Staff Report

Report To:	Planning and Development Committee		
Date of Meeting:	December 7, 2020	Report Number:	PSD-055-20
Submitted By:	Faye Langmaid, Acting Director of Planning and Development		
Reviewed By:	Andrew C. Allison, CAO	Resolution#:	PD-211-20, PD-212,20 C,529-20
File Number:	COPA 2020-0002; PLN 41.10	By-law Number:	
Report Subject:	Southeast Courtice Secondary Plan – Recommendation Report for Official Plan Amendment 124

Figure 3: Demonstration Plan

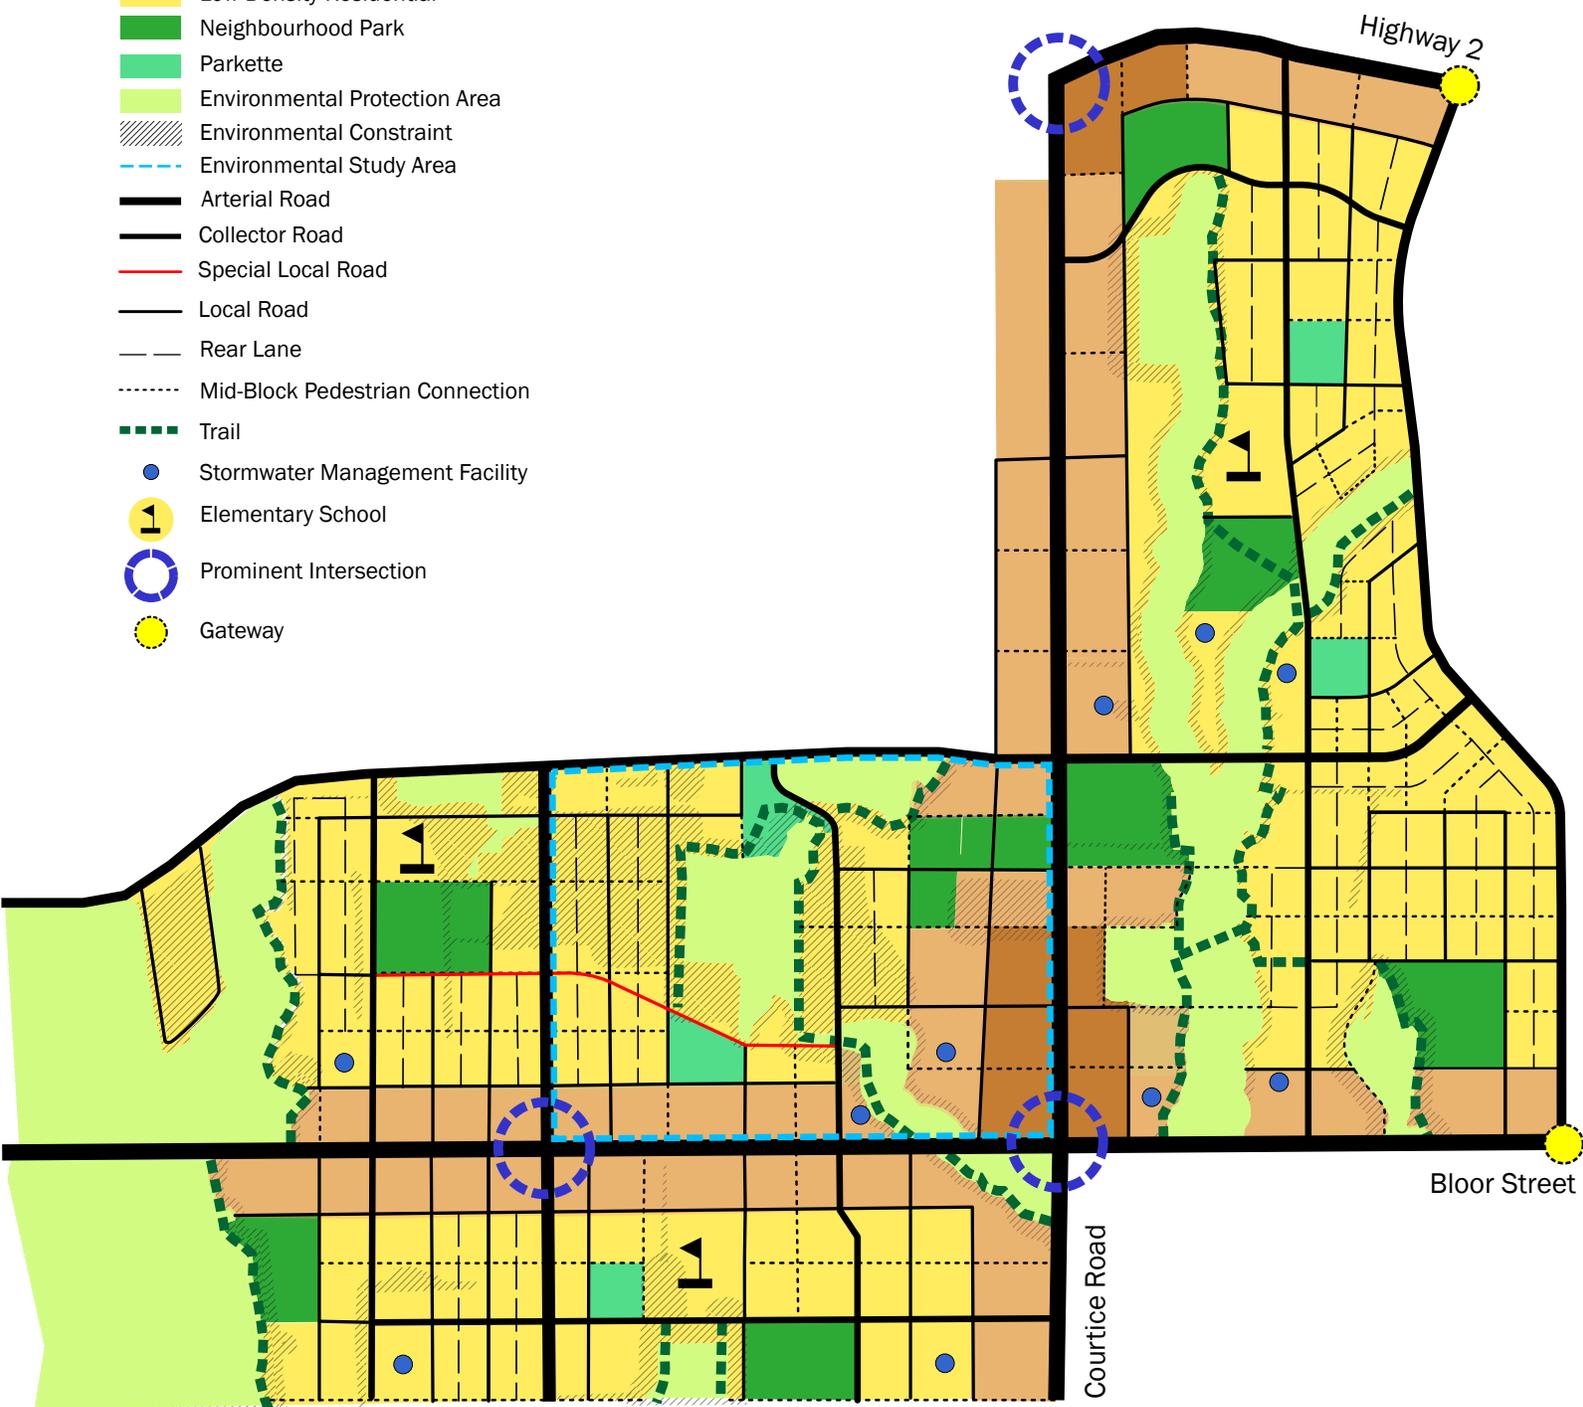
GRAPHICS	
	<p>Figure 4: Existing Context & Text</p> <ul style="list-style-type: none"> • Text and graphic boundary do not match that of the Secondary Plan. The SP states the east boundary is bound by Hancock Road, not Hwy 418 as stated in the UDG. 	<p>Graphics have all been revised. See the revised UDSGs Figure 1.</p>
	<p>Figure 5: SEC Demonstration Plan</p> <ul style="list-style-type: none"> • The Figure does not match with the Secondary Plan. SECSP boundaries don't match. 	<p>Graphics have all been revised. See the revised UDSGs Figure 3.</p>

Figure 4: Community Structure

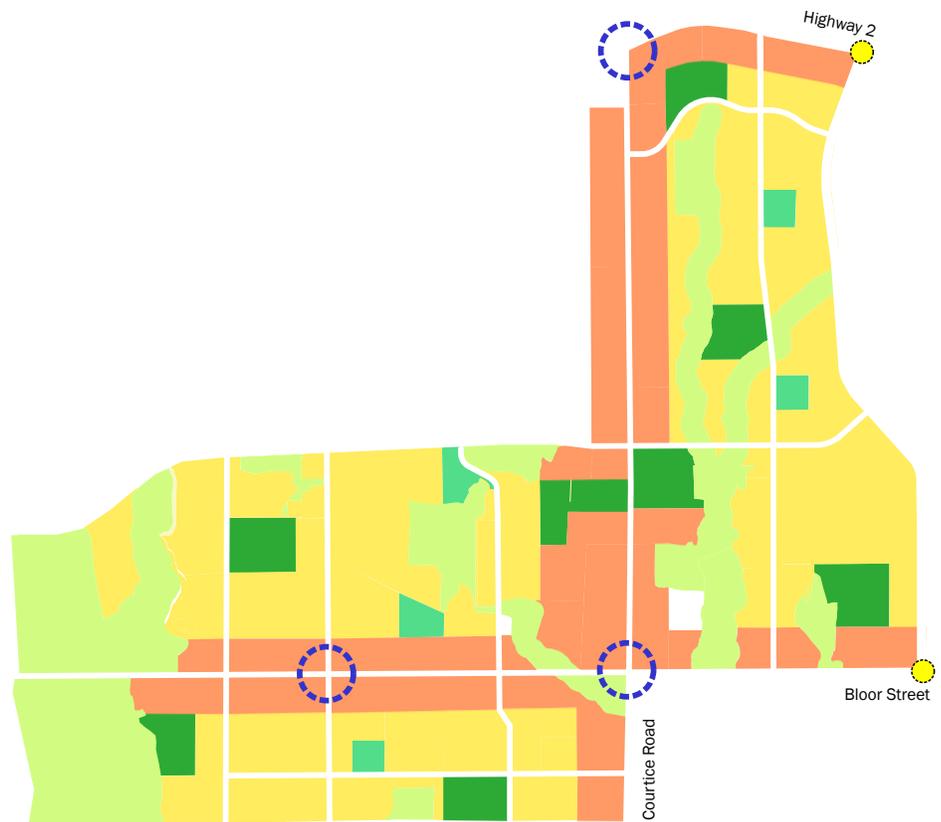
Submission Number Name (contact) Date	Details of Submission	Response
	Figure 6: Community Structure <ul style="list-style-type: none"> Map has no legend. 	Graphics have all been revised. See the revised UDSGs Figure 4.
	Figure 7: Environmental Protection Area <ul style="list-style-type: none"> Secondary Plan area boundary should be bolder and more readable. EP should be PEA to match first sentence at top of page. 	Graphics have all been revised. See the revised UDSGs.
	Figure 8: Intensification Areas <ul style="list-style-type: none"> There is no legend item for the extended light orange for Figure 8 in the UDG. Is this meant to be an extension or buffer of the Regional Corridor? 	Graphics have all been revised. See the revised UDSGs.
	Figure 9: Prominent Intersections <ul style="list-style-type: none"> Same graphic problems as noted above. 	Graphics have all been revised. See the revised UDSGs Figure 6.

Figure 31: Conceptual Demonstration of Public Realm Components

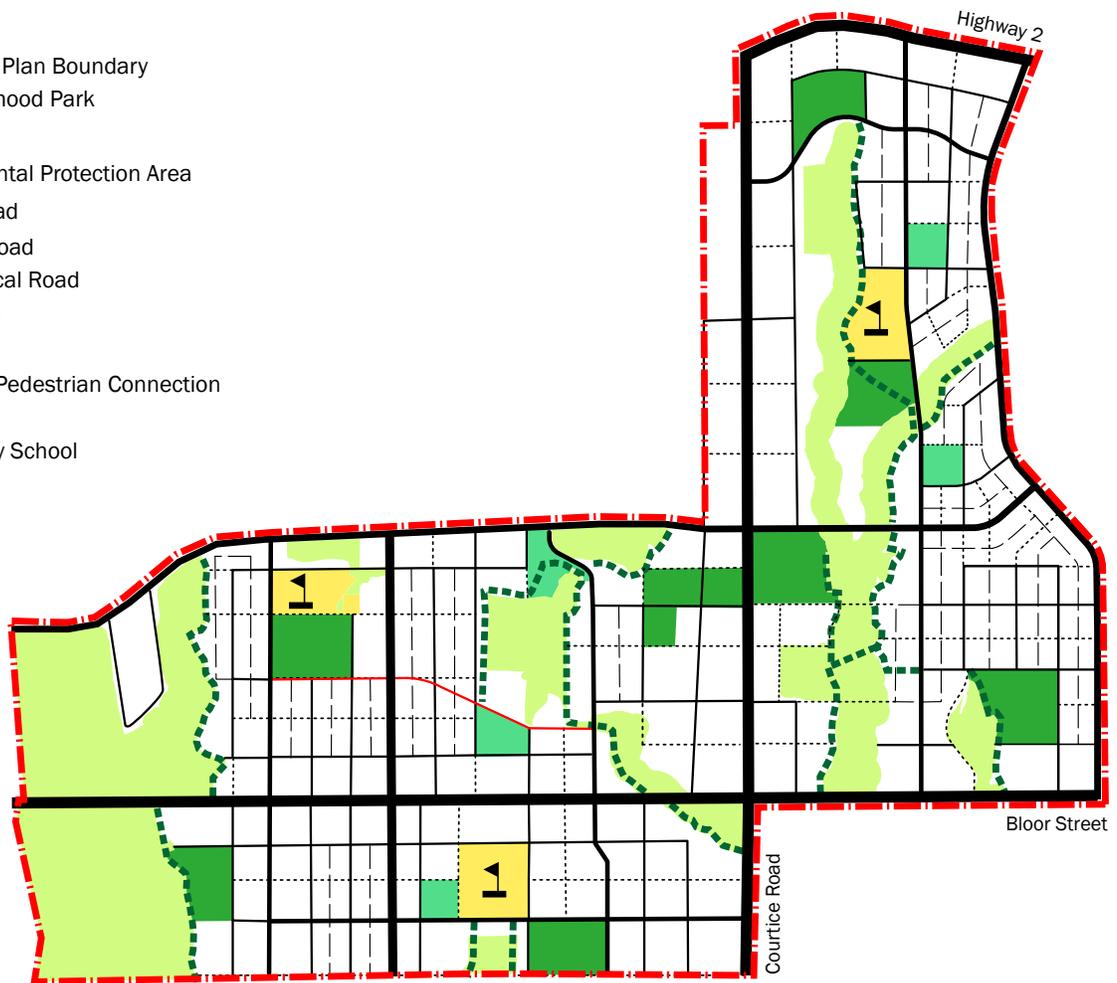
Submission Number Name (contact) Date	Details of Submission	Response
	<ul style="list-style-type: none"> Map has the same graphic problems. The meaning of the diagrams at the bottom of the page are provided without explanation and appear to have no meaning. Reference to POPs in the legend and on the Figure is not clear. 	
	<p>Figure 13: Siting, Built Form and Massing</p> <ul style="list-style-type: none"> Map has incomplete legend. Figure 13 doesn't reflect Guidelines. 	Graphics have all been revised. See the revised UDSGs.
	<p>Figure 14: Built Heritage and Cultural Resources</p> <ul style="list-style-type: none"> Map needs legend. The building identified as BHR4 has been determined by the Heritage Committee to NOT have any heritage value. The Town has issued a demolition permit. Please remove. 	Graphics have all been revised. See the revised UDSGs Figure 59.
	<p>Figure 15: SEC Public Realm</p> <ul style="list-style-type: none"> Figure is too small, no legend. Should be consistent with Section 2 preamble page. 	Graphics have all been revised. See the revised UDSGs Figure 31.

Figure 43: Type A Arterial (Multi-Way) Cross-section and Plan

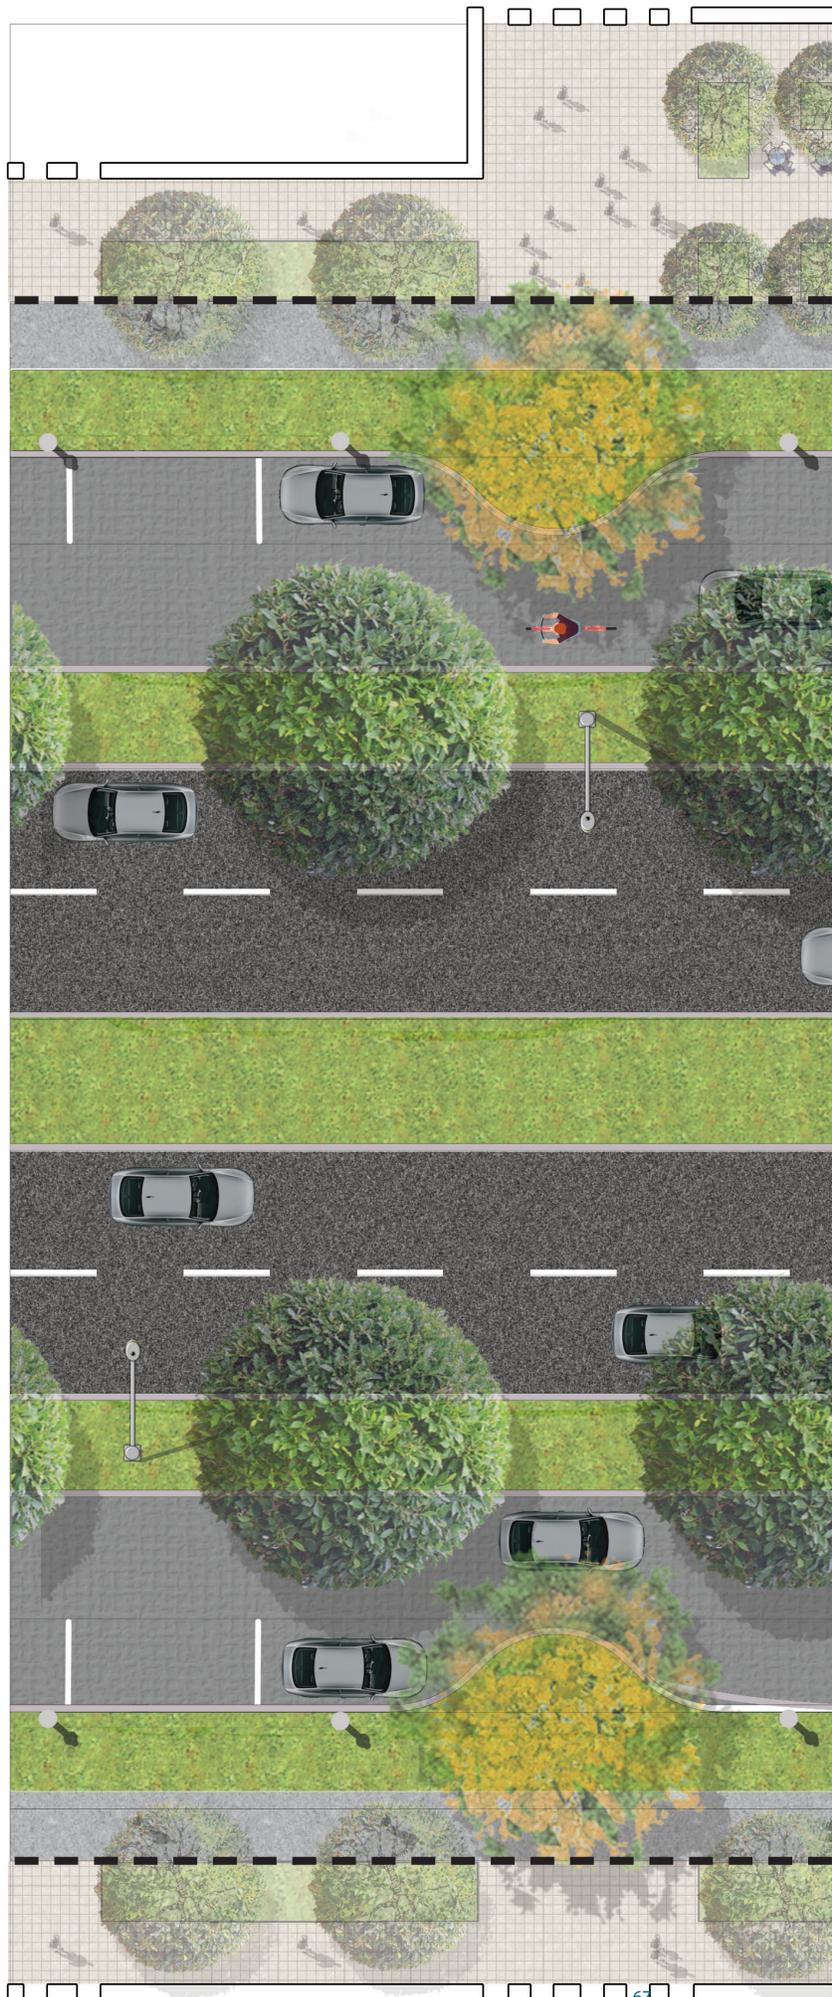
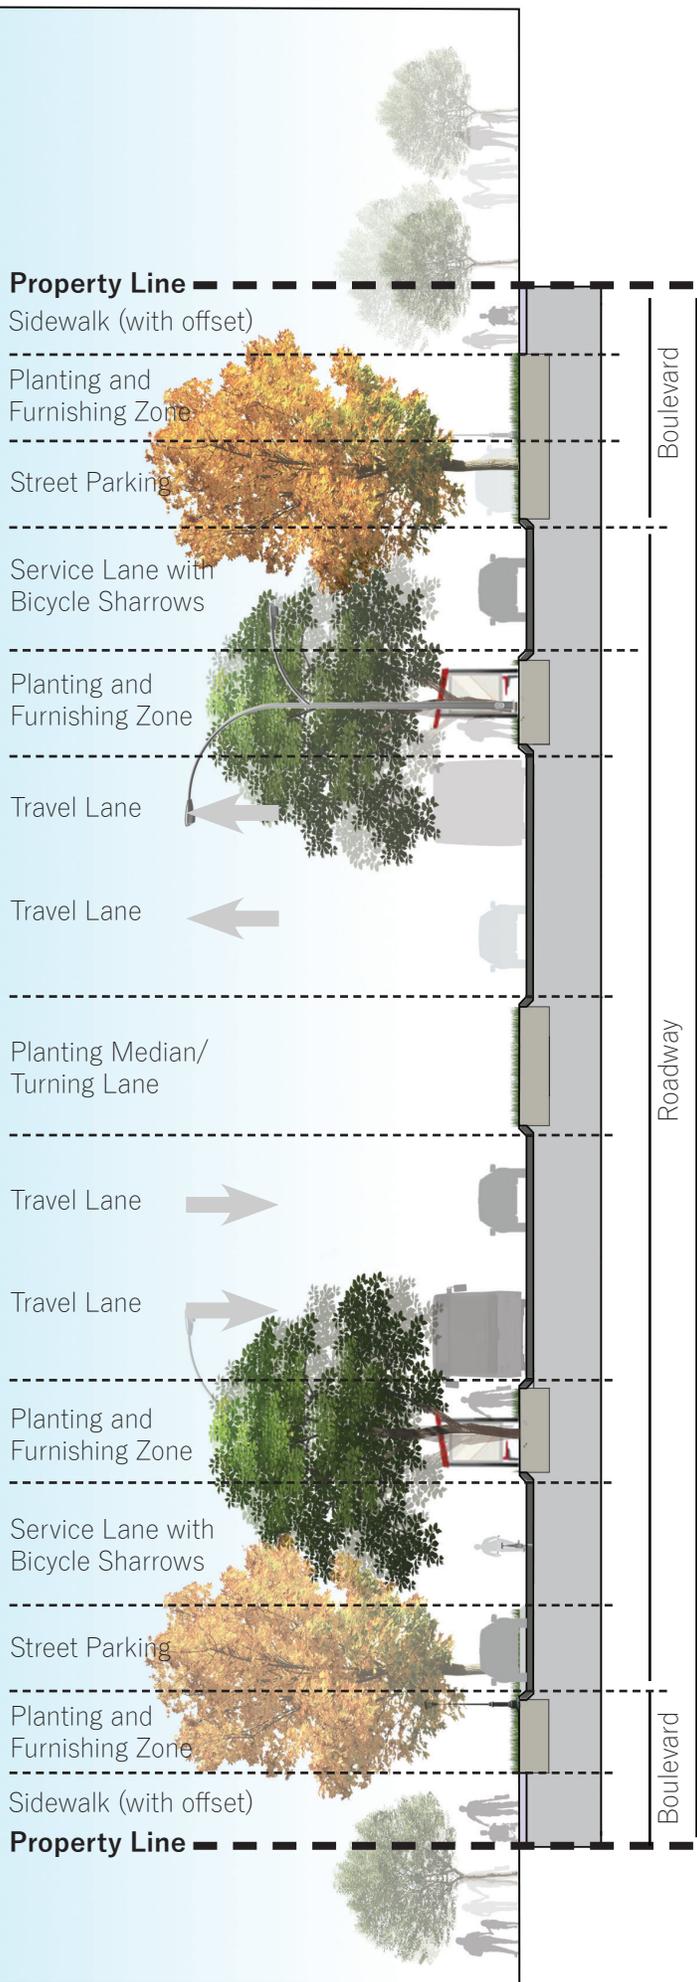
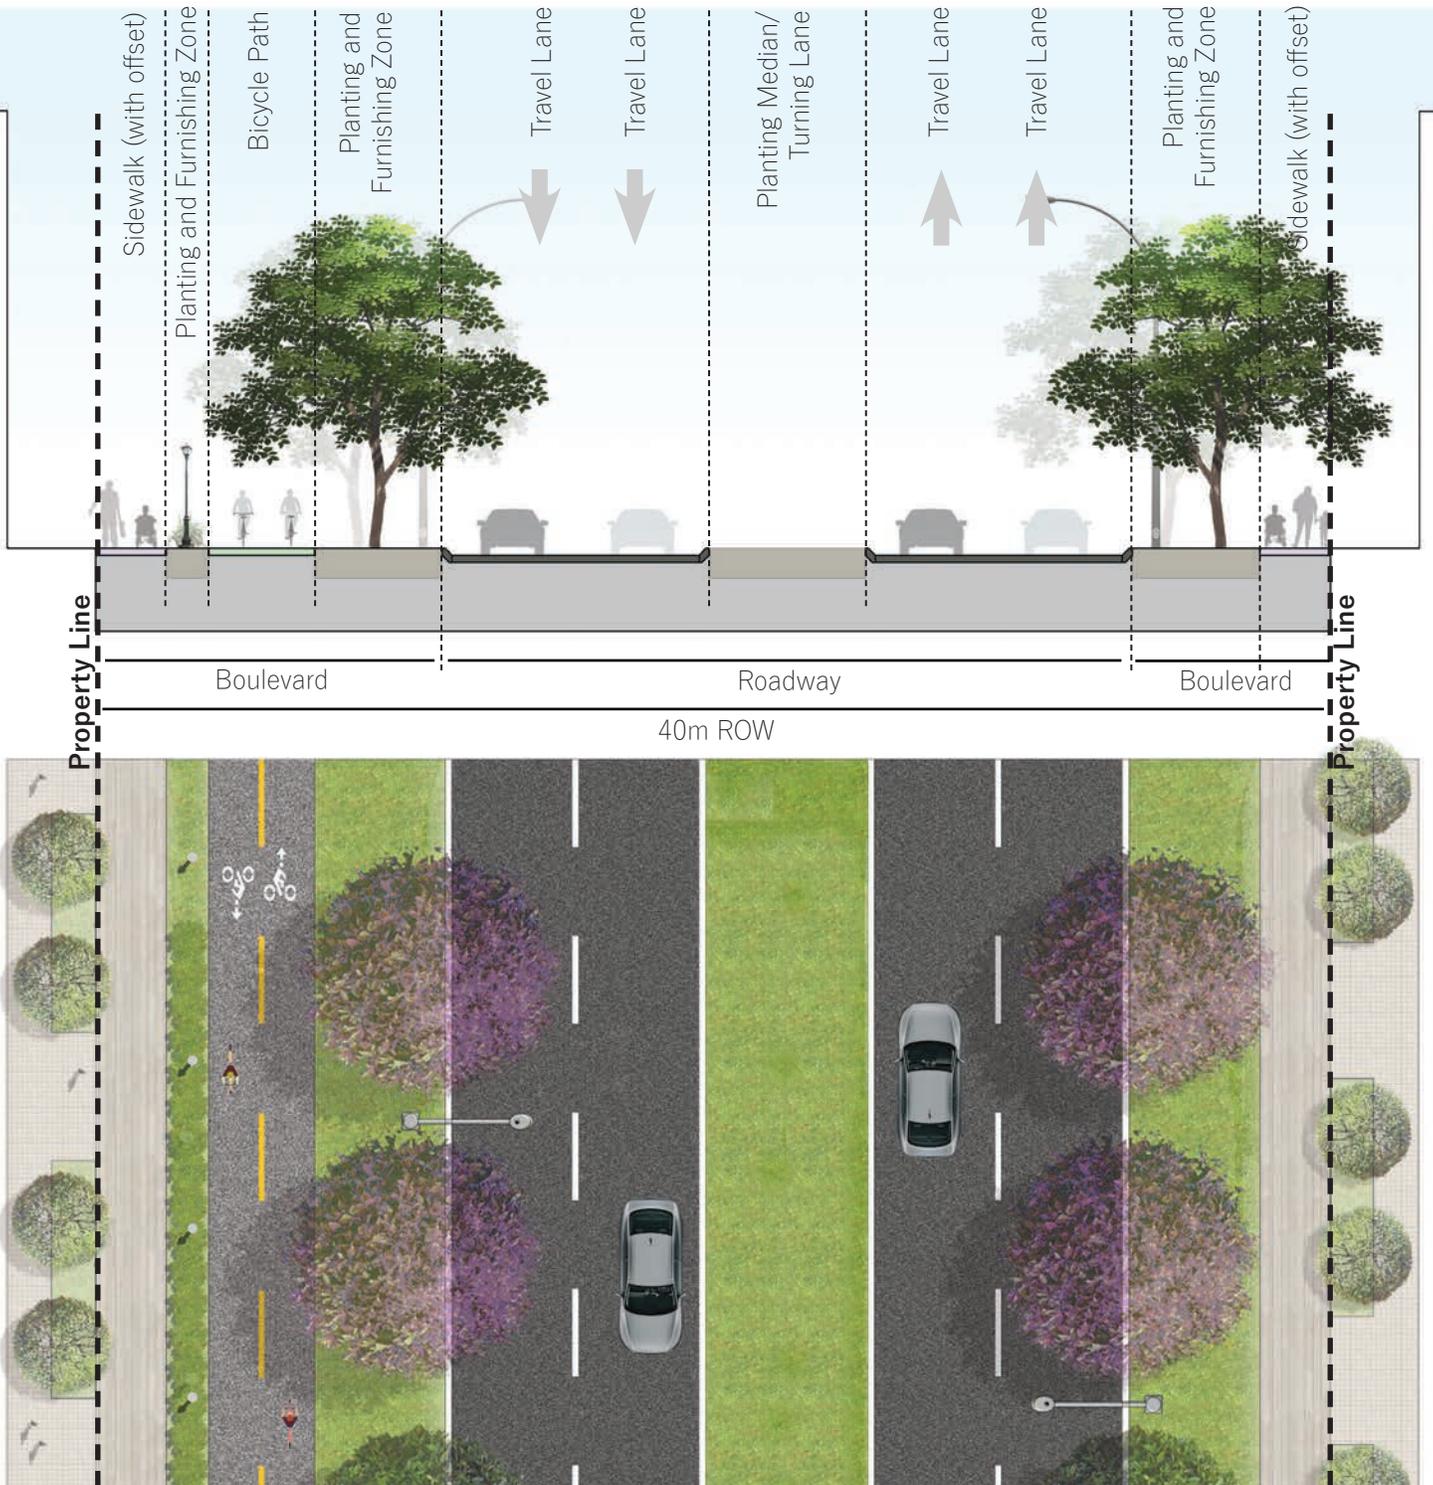
<p>Figure 16: Access and Circulation</p> <ul style="list-style-type: none"> Photo is unimplementable. Too much permeable paving, curb side parking both sides and based on previous guidelines assumes that the multi-storey buildings (mixed use) framing would represent the "Main Street" or regional corridor. 	Graphics have all been revised. See the revised UDSGs.
	<p>Figure 17: Road Network</p> <ul style="list-style-type: none"> Legend has an error. The water course colour has been used for a road type. The Local Roads are missing from the legend. However, local roads should be deleted. 	Graphics have been revised. See the revised UDSGs Figure 41.
	<p>Figure 18: Arterial A (Frontage Road/Multi-way)</p> <ul style="list-style-type: none"> The Regional Transportation Master Plan doesn't contain cross sections however, the Executive Summary does refer to the Arterial Corridor Guidelines developed within the scope of the TMP (links 	New Graphic Added for Arterial A. Region of Durham has provided assistance.
